BV2.5 (M2.5-Note) SYSTEM BLOCK DIAGRAM

PROJECT : BV2A
Quanta Computer Inc.

BV2A / M2.5-Note Schematic EC Tracking Record A (for SDV) Feb. 22, 2006**EC #/Page/Description/Part Affected/CMVC #****83**

LCD CONNECTOR

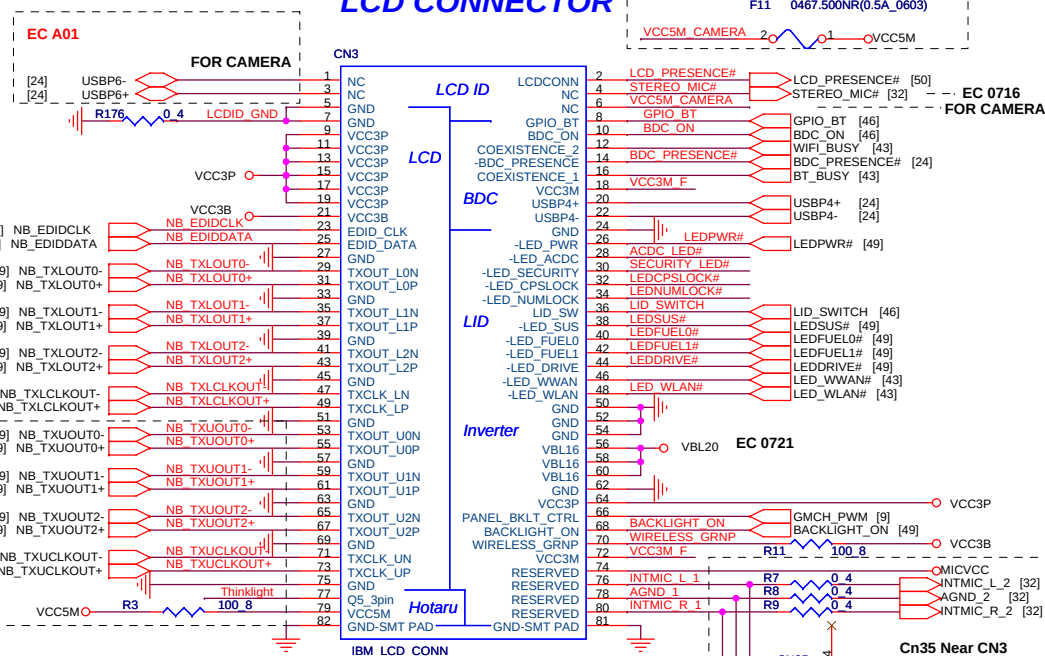
EC 0718
Delete BACKLIGHT_ON pull up.

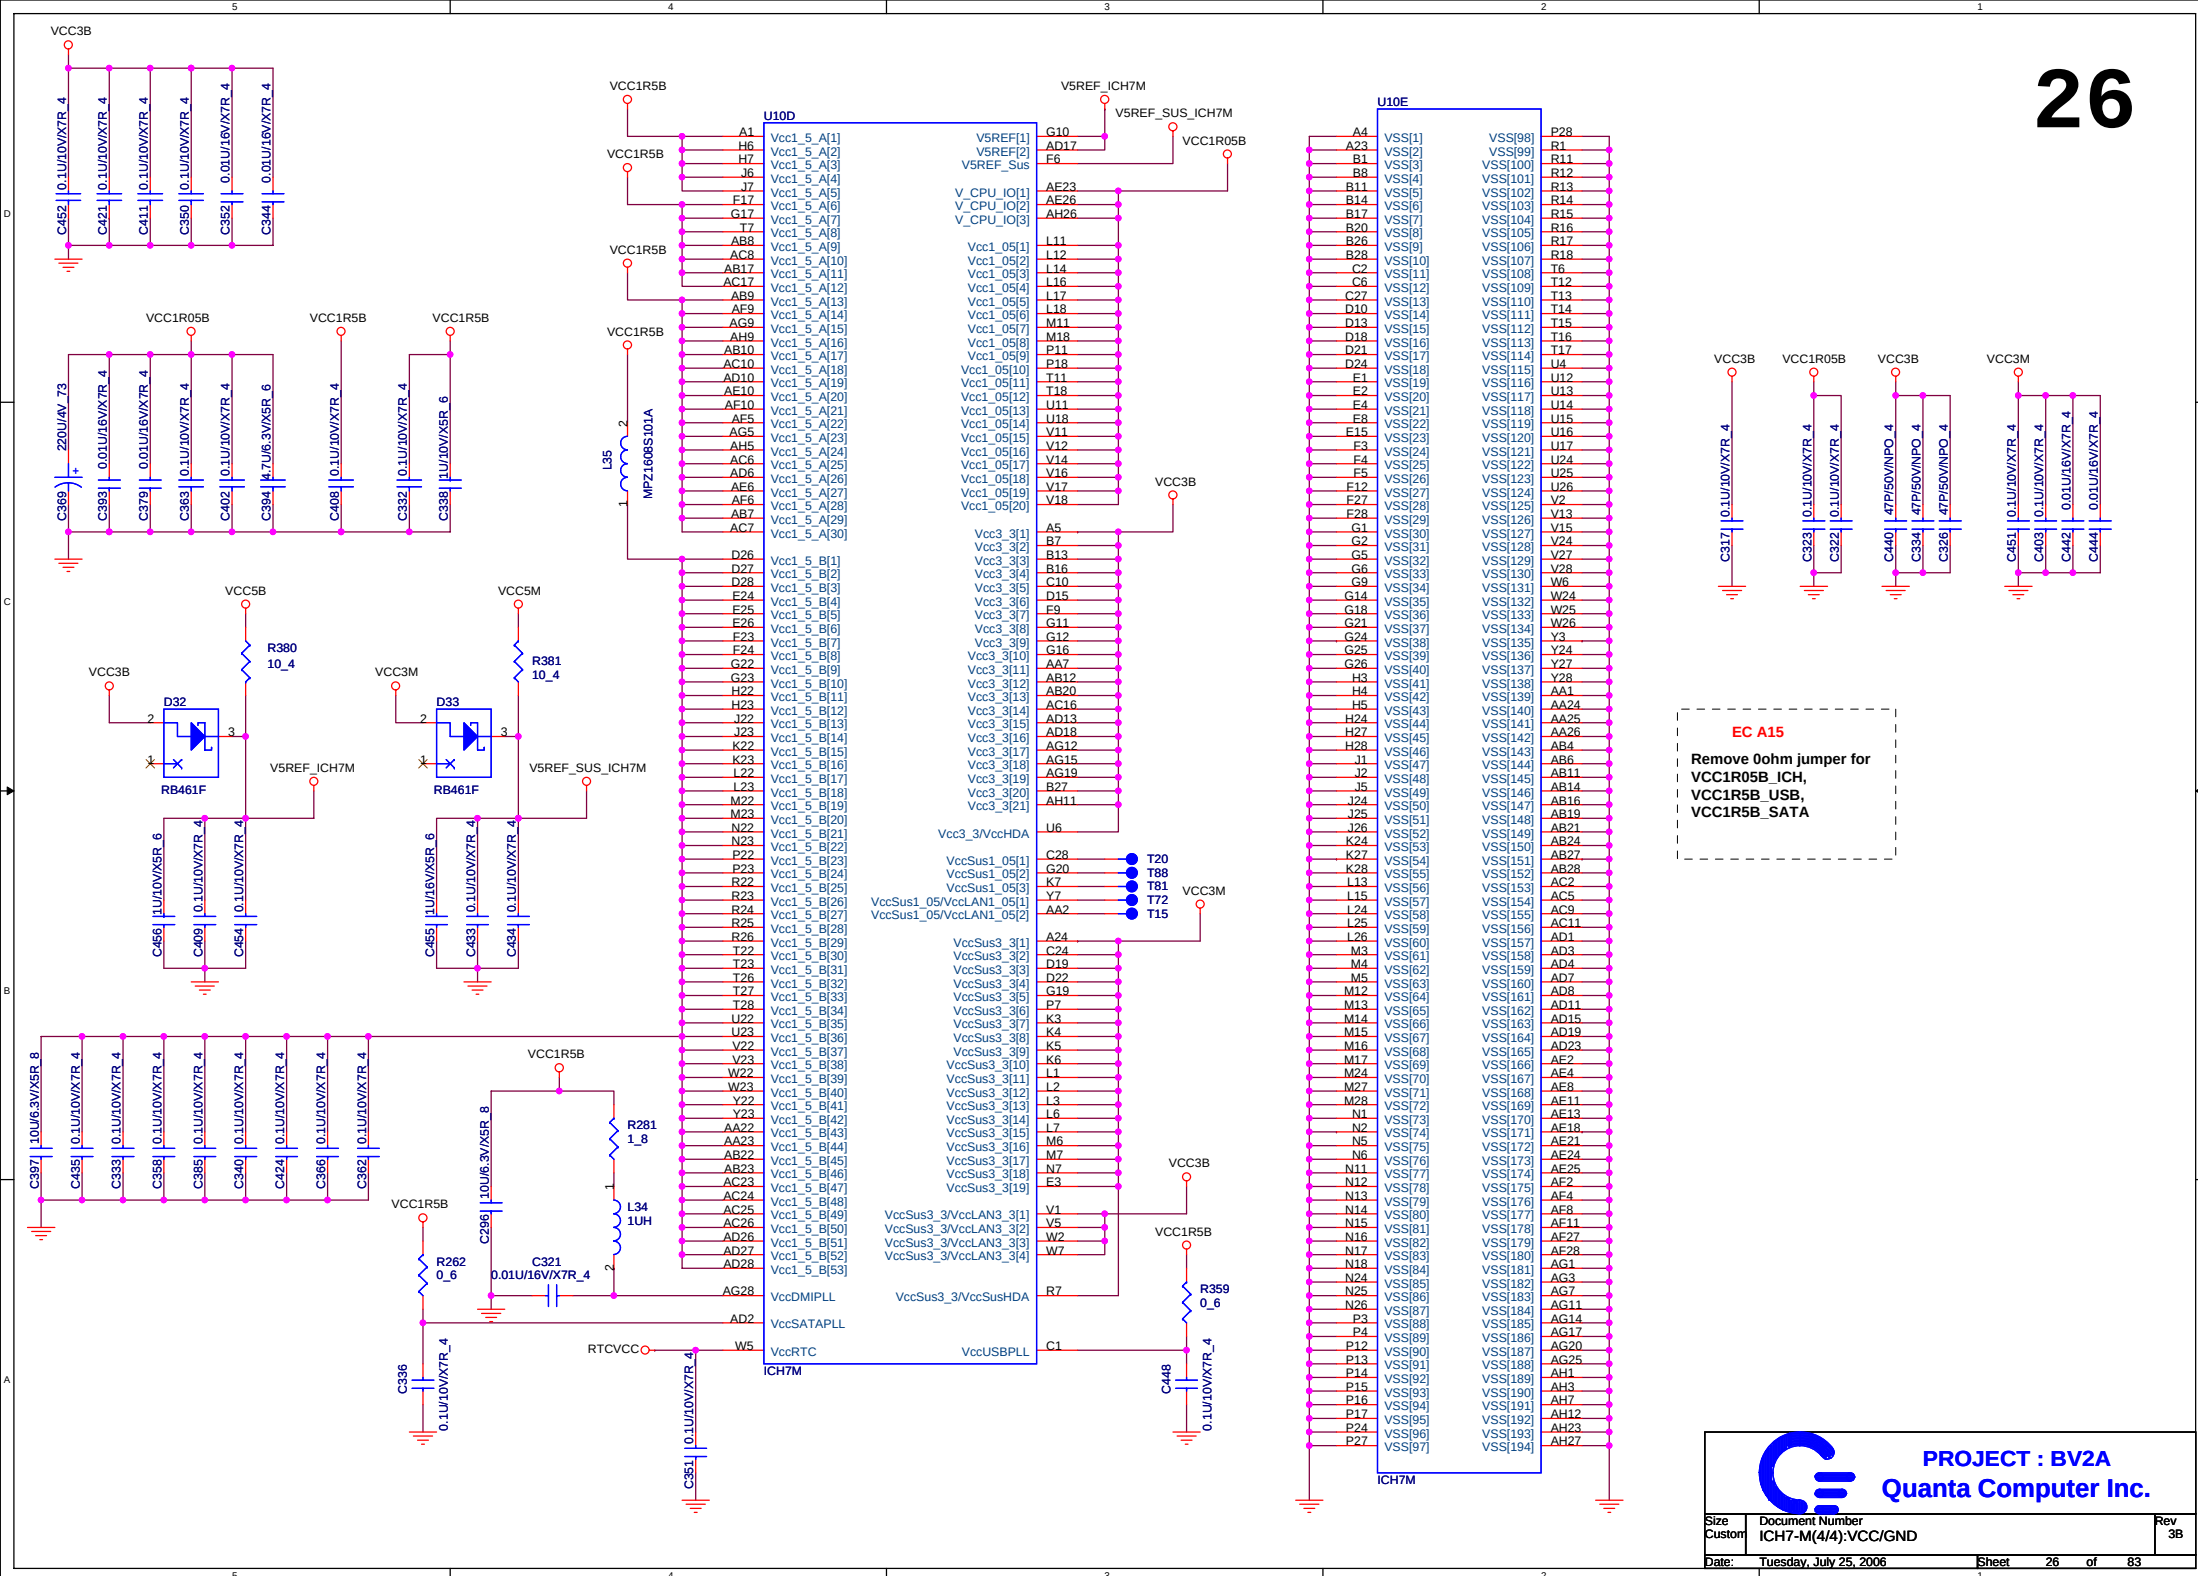
EC 0714 NO TEST PAD FOR SATA SIHNAL.

USB Bracket

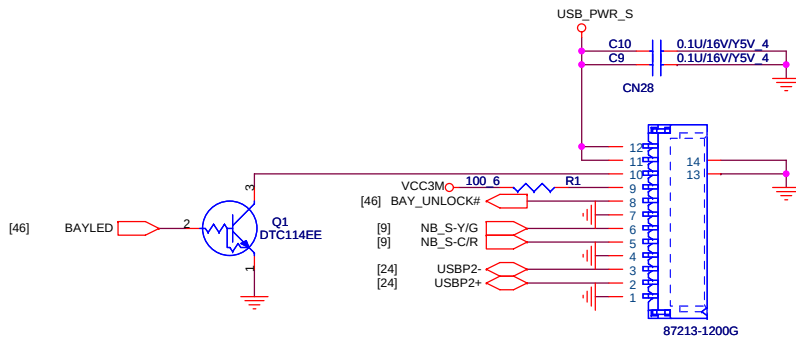
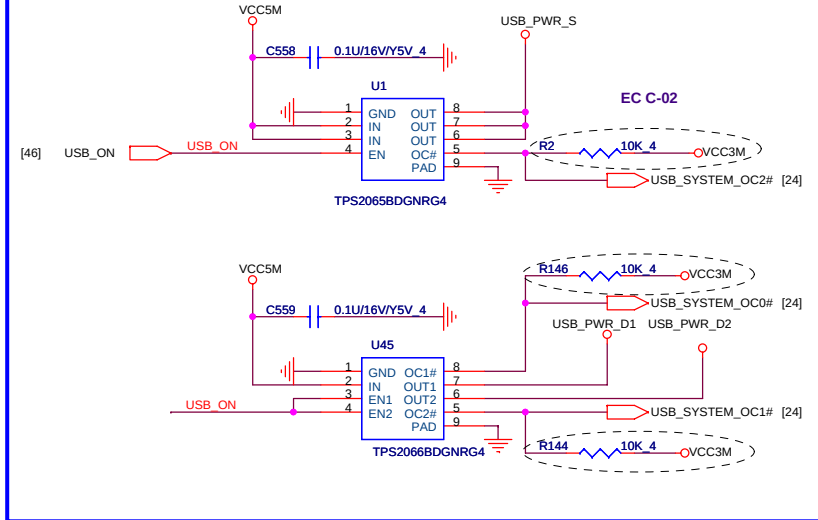
Change to TI solution (TPS2051B + TPS2052B power switch)

Change to TI solution (TPS2065 + TPS2066 power switch) EC A16

Add Thermal pad EC B03

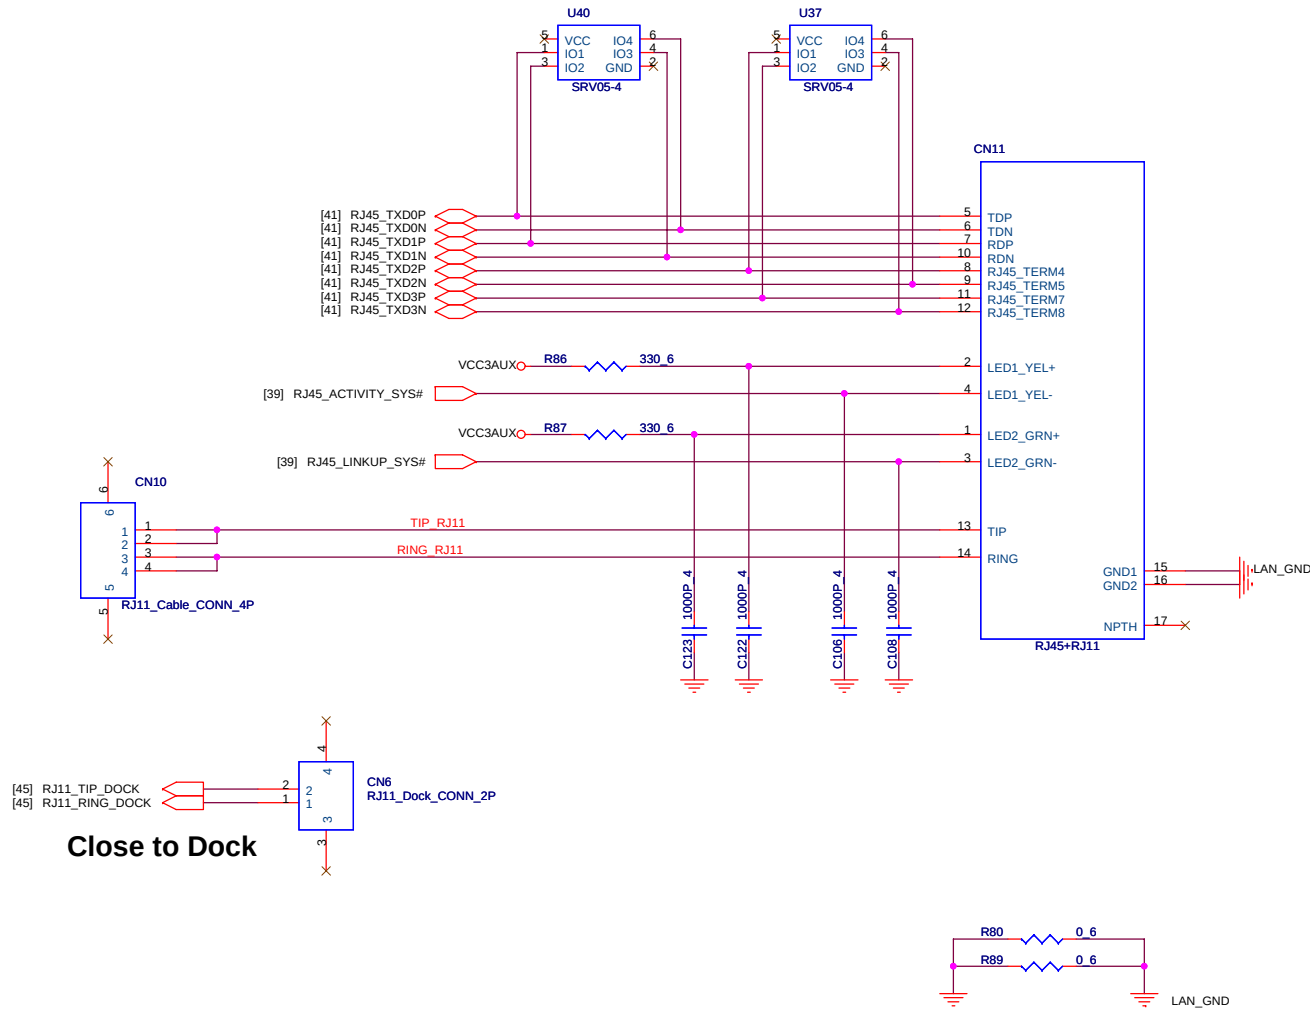
Delete Debug CONN

EC A23
